UNITED STATES PATENT AND TRADEMARK OFFICE

| APPLICATION NO. | FILING DATE | FIRST NAMED INVENTOR | ATTORNEY DOCKET NO. | CONFIRMATION NO. |
|---|-------------|----------------------|---------------------|------------------|
| 09/751,208 | 12/29/2000 | Kenneth S. Bailey | VTC.0107 | 8869 |

| Office Action Summary | Application No. 09/751,208 | Applicant(s) BAILEY ET AL. | |

DETAILED ACTION

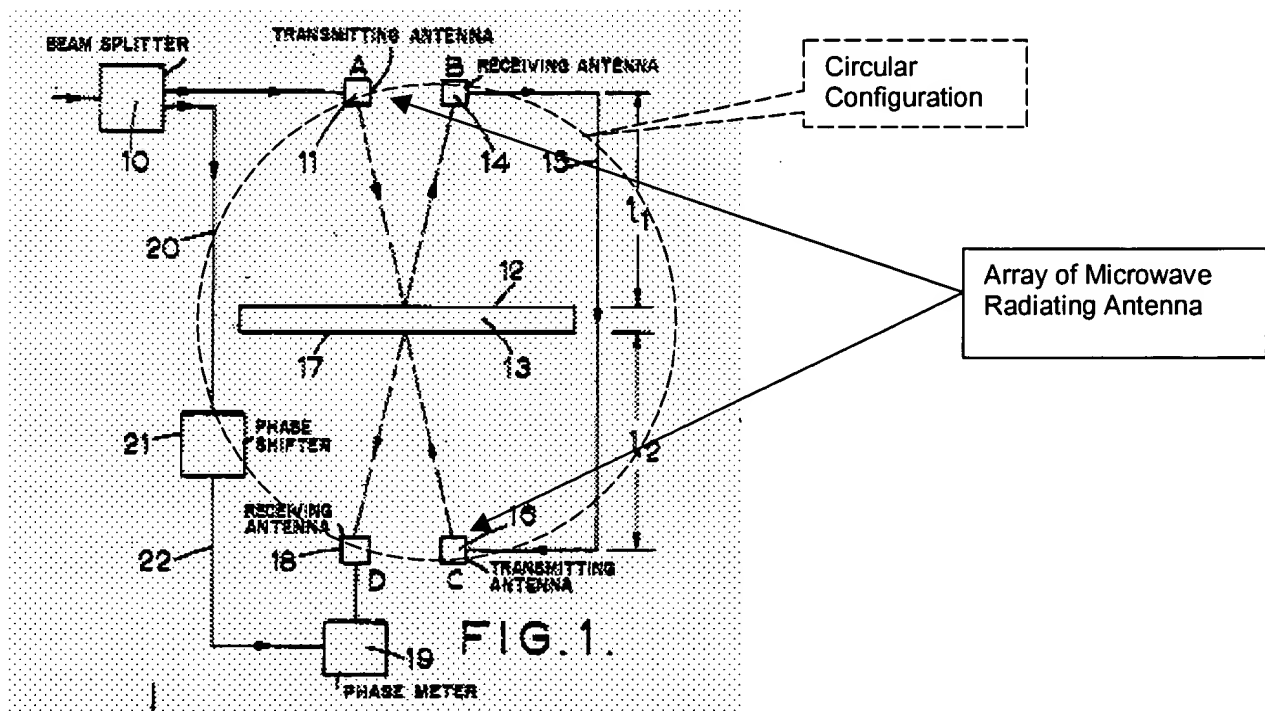
2. The drawings are objected to under 37 CFR 1.83(a). The drawings must show every feature of the invention specified in the claims. Therefore, the "server", the "means for relaying said measured dimensions from said processor means", (e.g. claim 11) must be shown or the feature(s) canceled from the claim(s). No new matter should be entered.

It is noted that the item 110, as applicant mentioned in the amendment filed on May 20, 2004, is not found in the drawings.

A proposed drawing correction or corrected drawings are required in reply to the Office action to avoid abandonment of the application. The objection to the drawings will not be held in abeyance.

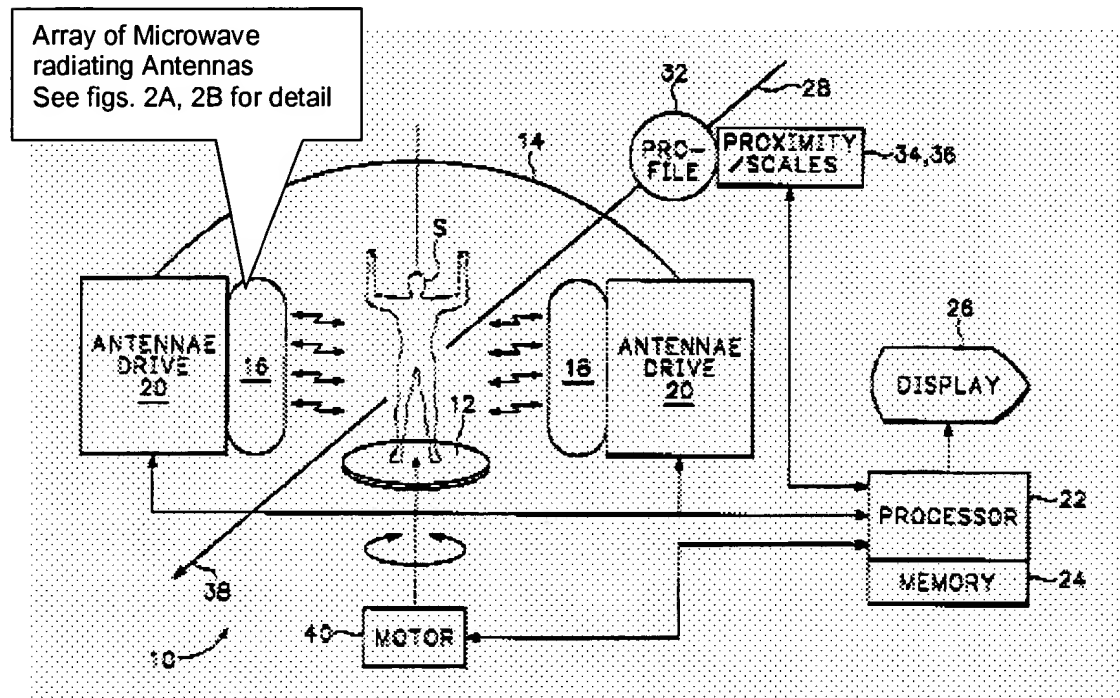
Regarding claim 1, Williams discloses an apparatus and method for measuring dimensions of an object comprising (figure 1) a source (Connects to element 10) of microwave signals having a predetermined amplitude and frequency (The amplitude/frequency is predetermined by the state of the system; see also figures 4-6 and their corresponding through out the entire disclosure) including an array of microwave radiating antennas (11, 16), spaced from one another long a first direction (Arrow direction); at least one microwave receiver antenna (14) which is located spaced from said radiating antennas (11, 16) along a second direction which is substantially orthogonal to said first direction during a time of scanning.

Regarding claim 7, William discloses said radiating antenna are arranged along a circular configuration (See dash lines on the attached figure above).

The spaced from each other and the orthogonal direction are read on Williams as the examiner illustrated in the figure above.
